Access Compliance Report Public Rights-of-Way (Curb Ramps)

Intersection ID: 10021763Main Street: BRICK_CHURCH_CTCross Street: N/ALocation:NWADA ID: 15DA81783712Ramp Type: PerpInitial Pass/Fail: FailOverall Compliance: NoSeverity Score: 33.75

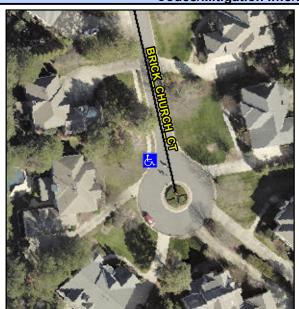
Field Measurements/Component Compliance					
Comp	liance Description	Data	Comp	liance Description	Data
N/A	Ramp Length (in)	89.0	No	Ramp Slope (%)	8.9
No	Ramp Width (in)	41.0	No	Ramp XSlope (%)	5.4
N/A	Flare Type LT	N/A	N/A	Flare Type RT	N/A
N/A	Flare Slope LT (%)	N/A	N/A	Flare Slope RT (%)	N/A
N/A	Flare Traversable LT?	N/A	N/A	Flare Traversable RT?	N/A
N/A	Landing Length (in)	N/A	N/A	DWS Provided?	N/A
N/A	Landing Width (in)	N/A	N/A	DWS Contrast?	N/A
N/A	Landing Slope (%)	N/A	N/A	DWS Length (in)	N/A
N/A	Landing X Slope (%)	N/A	N/A	DWS Full Width?	N/A
N/A	Landing Curb? (Y/N)	N/A	N/A	DWS Offset (in)	N/A
N/A	Shared Landing?	N/A			
N/A	Gutter Ponding?	N/A	N/A	Gutter Slope (%)	N/A
N/A	Gutter Lip Ht (in)	N/A	N/A	Gutter X Slope (%)	N/A
N/A	Painted X Walk1?	No	N/A	Painted X Walk2?	N/A
	X Walk 1 Direction	To SE		X Walk 2 Direction	N/A
N/A	X Walk 1 Width (in)	N/A	N/A	X Walk 2 Width (in)	N/A
	X Walk 1 Slope (%)	3.9		X Walk 2 Slope (%)	N/A

X Walk 1 X Slope (%)	1.2		X Walk 2 X Slope (%)	N/A
N/A	Ramp inside XWalk1?	N/A	N/A	Ramp inside XWalk2?	N/A
	Road Slope (%)	N/A	N/A	Clear Space?	N/A
	Road X Slope (%)	N/A	N/A	Clear Space to XWalk (in)	N/A
N/A	Any Obstructions?	N/A	N/A	Storm Grate/Utility Hazard?	N/A
	Obstruction Type			Storm Grate/Utility Type	
		N/A			N/A
			Yes	Surface Condition? (G/P)	Good
1

Remove & Replace Entire Ramp.

R304.5.1, R304.2.2, R304.5.3
